UNITED STATES PATENT AND TRADEMARK OFFICE

10/523,584

Office Action Summary	Application No.	Applicant(s)	
	10/523,584	DUPONT ET AL.	
	Examiner	Art Unit	
	Vinh T. Luong	3682

ATTACHMENT

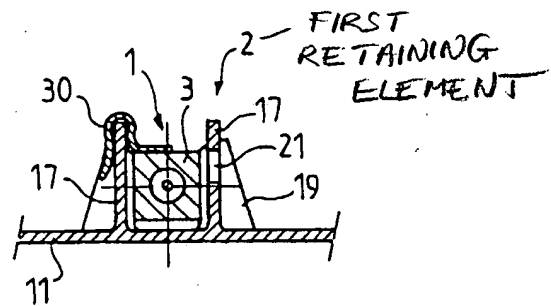
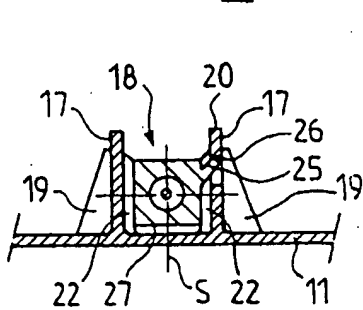
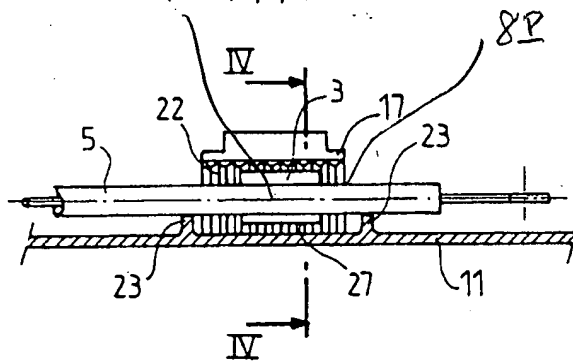
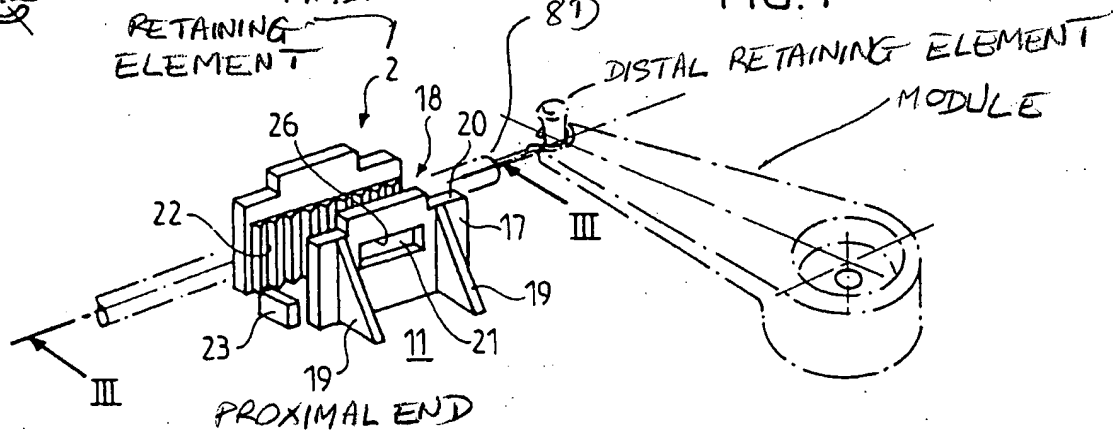
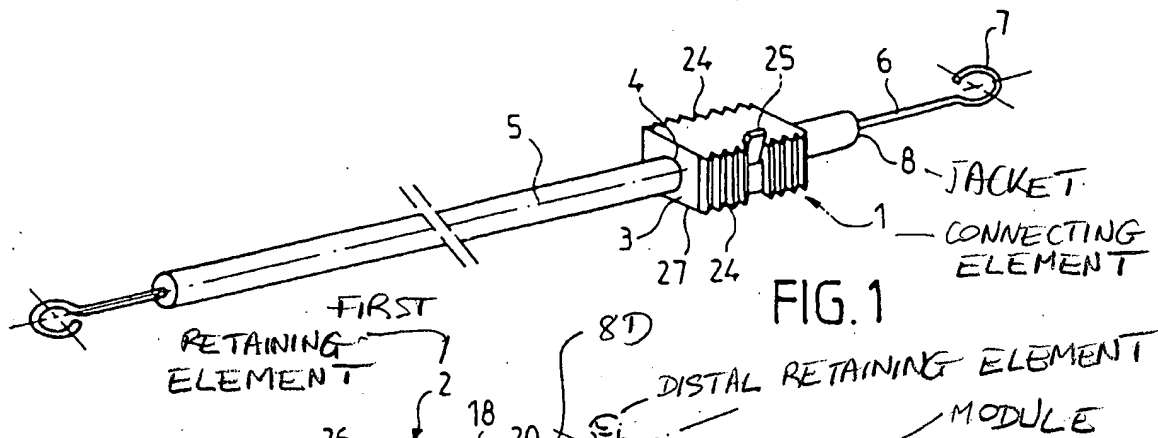
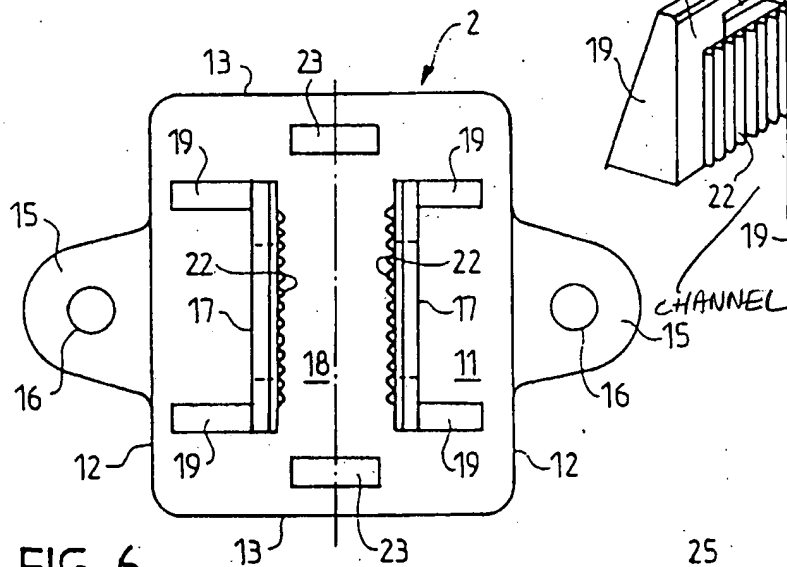
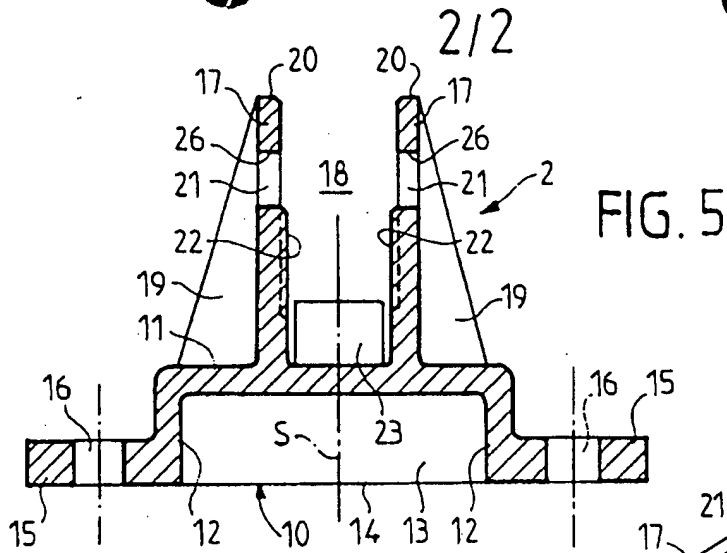
Regarding claim 1, Michel teaches a control device for a module (unnumbered, shown by dashed line in Fig. 2. See Attachment hereinafter "Att.") forming a lock mechanism, of the type comprising a Bowden-type cable containing a cable 6 having two ends, a proximal end (Att.) and a distal end respectively, the cable 6 being housed in a jacket 8 having two ends, a proximal end (8P in Att.) and a distal end (8D in Att.) respectively, which are immobilized by two proximal 1 (Fig. 1) and distal (see Fig. 2 in Att.) retaining elements, characterized in that at least a first end (8P in Att.) of the jacket 8 is connected to a corresponding first retaining element 2 (Figs. 5 and 7) by means of a connecting element 1 attached to the first end of the jacket 8.

Regarding claim 10, the first end of the jacket 8 is its proximal end (8P in Att.).

Regarding claim 11, the proximal end (8P in Att.) of the cable 6 is provided with a block 7 (Fig. 8) for securing this cable 6, the shell 12 forming a housing for this securing block 7.
